Land retention system adjacent to a boundary

1 THE MATTER TO BE DETERMINED

- 1.1 The matter before the Authority is a dispute about the adequacy of a land retention system (“the system”) associated with a building constructed adjacent to a boundary.

- 1.3 For the reasons set out in 4 below, the Authority takes the view that it is being asked to determine, under section 17 of the Building Act 1991 (“the Act”), whether the system as installed complies with clauses B1 Structure and B2 Durability of the building code (the First Schedule to the Building Regulations 1992).

Figure 1: The elemental wall

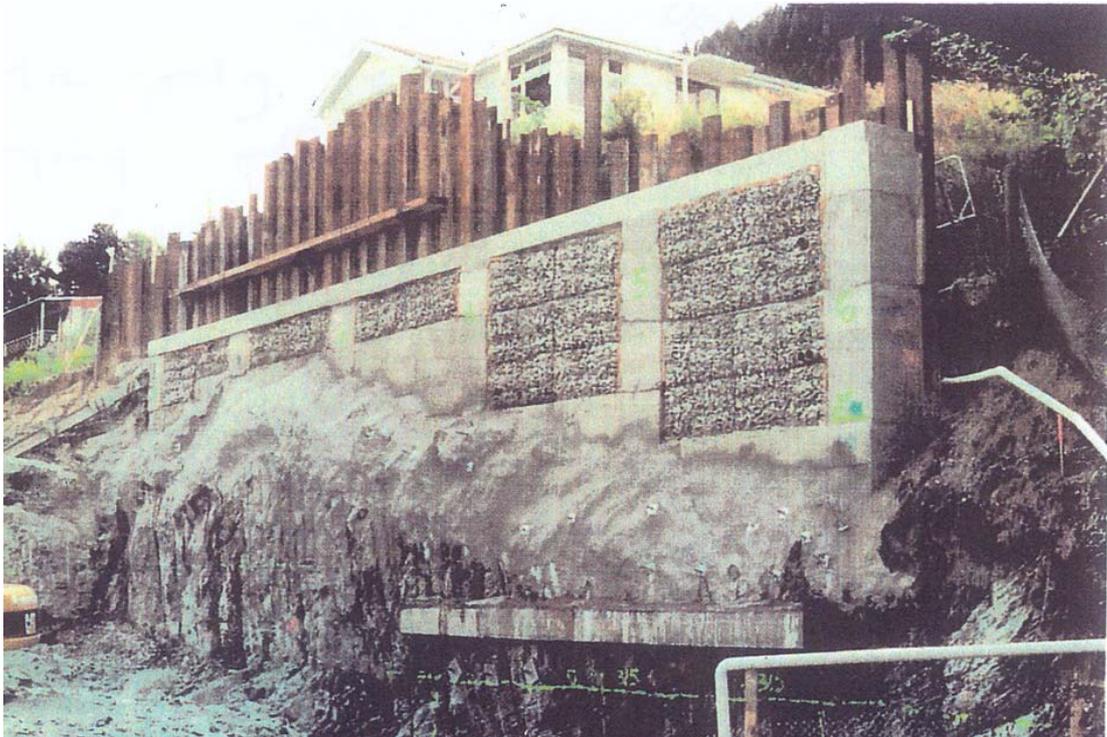
6.4.3.1 The gabion baskets are made of plain galvanised wire. That is clearly inadequate. The Authority accordingly considers that the gabion baskets as originally installed do not have adequate protection against corrosion.

6.4.4.1 The elemental wall relies on the shear resistance of non-galvanised reinforcing bars from the columns and the bottom beams of the frame that are grouted into bedrock with cementitious grout. The applicant’s consultant asked whether those rods “meet the requirements of durability for even single corrosion protection”.

“The writer has not seen any details of the anchors used to tie back the columns to the rock, apart from the fact that these are 32Ø and 28Ø bars cement grouted 3.5m and 1m respectively into rock. The anchors are understood to be ungalvanised reinforcing bars. These would not comply with the requirements for single corrosion protection for steel tendons used for ground anchorages.”

“[The Authority’s consultant] agrees that the durability of these anchors do not meet the requirements for corrosion protection of these critical elements. As this wall forms a critical part of the support of the upper 5-6m of the slope retention system we consider this alone should be grounds for additional support to be provided.”

“ . . . the face-fixing [to the gabions] of a . . . zinc-aluminium coated wire mesh system. This has been assessed to provide in excess of the 50 year durability requirements of the NZ Building Code, and will be a requirement to be installed prior to a Code Compliance Certificate being issued . . . ”

willing to accept that the reinforcing bars comply with clause B2 subject to verification that failure of the elemental wall will not result in the collapse of the building's upper floors.

8.1 In accordance with section 20 of the Building Act, the Authority hereby determines that the system, supplemented by backfill to RL 315 m, complies with the building code subject to verification, to the satisfaction of the territorial authority, that:

- (a) Failure of the elemental wall will not result in the collapse of the building's upper floors; and
- (b) The building has been designed for backfill to at least RL 315 m.
